Technical Bulletin

No: TCM-0089-B
ITCM-0066-B
Page 1 of 2

Product Compact Models: CHDC*, CRC*, DEC*, HDC*, MDC*, MCHDC*

Issue New manufacturing series P20038xxM

Antenna Shield 59154460. Changes include:

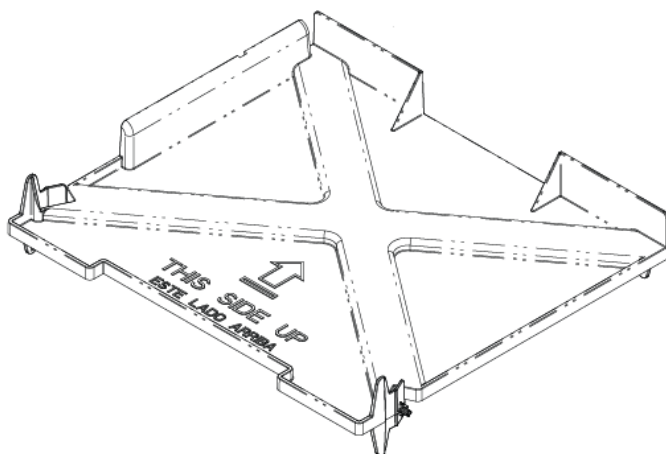
- release tabs on the front sides which fit into slots in the cavity.
- embossed orientation icons to remind installer of proper alignment.

NOTE: This new shield is **NOT** backward compatible with 59124202.

release tab

Ceramic Tray 59154461. Changes include:

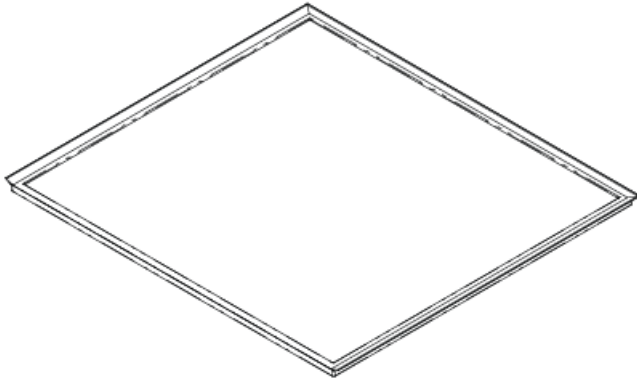
- new tray material
- gasketed tray includes pre-applied molded gasket. RTV sealant is no longer required.

NOTE: This new tray is **NOT** backward compatible with 14109040 or 14159092. Replacement part includes the tray only. Tray supports will need to be ordered separately, if needed.
